DESIGN REVIEW REPORT AND DECISION

File Number: DSRFY2026 - 0009

Review Status: APPROVED AS CONDITIONED

The applicant presented a design review consultation request for an accessory structure associated with an outdoor odor mitigation facility at Heron Park. The facility is intended to address longstanding sewer odor complaints along the Boise River Greenbelt by actively drawing air from the sewer system and treating it through an ozone-based vapor odor control system.

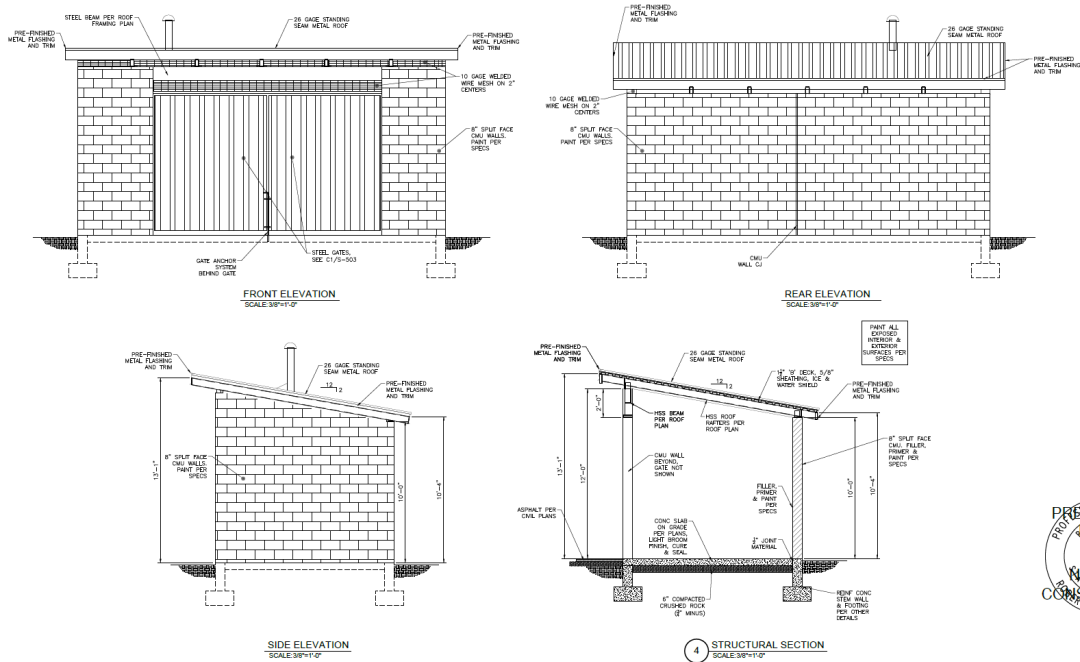
<p>The door shall be a roll-up door rather than doors that swing outwards from the facility.</p> <p>The consultant did not approve of the proposed location and instead recommended placing the building south of the restroom (see Exhibit A)</p>
8-4C-5 Prohibitions	No compliance issues noted	There are no visible false fronts, prefabricated structures or prohibited materials proposed with this application.
8-4E Transportation and Connectivity Provisions		
8-4E-3 Public Street Connections	Compliant as Conditioned	<p>This article provides design standards that shall apply <u>to any new construction, addition, expansion, grading, alteration, or any new or more intense use of property.</u></p> <p>A new accessory structure is proposed to be connected to the public street via a pathway.</p>
8-4E-4 Internal Circulation Standards	Compliant as Conditioned	<p>Driveways, aisles and turnaround areas, when required for fire and refuse access, shall meet the following standards:</p> <ol style="list-style-type: none"> 1. Have a minimum vertical clearance of thirteen feet six inches (13'6") for their entire length and width. 2. Have a minimum width of twenty feet (20'). 3. The design of internal circulation should be integrated with the overall site design and adjacent properties, including the location of structures, pedestrian walkways and landscaping.

2. The ability to serve shall be provided.
3. The structure shall be relocated to a location that is less visually and functionally obtrusive to the park and its planned future improvements. The final location shall be consistent with the recommendation of the Design Consultants dated May 18, 2026, placing the structure between the existing restroom and the tree adjacent to Reed Street, as generally depicted in Exhibit A.
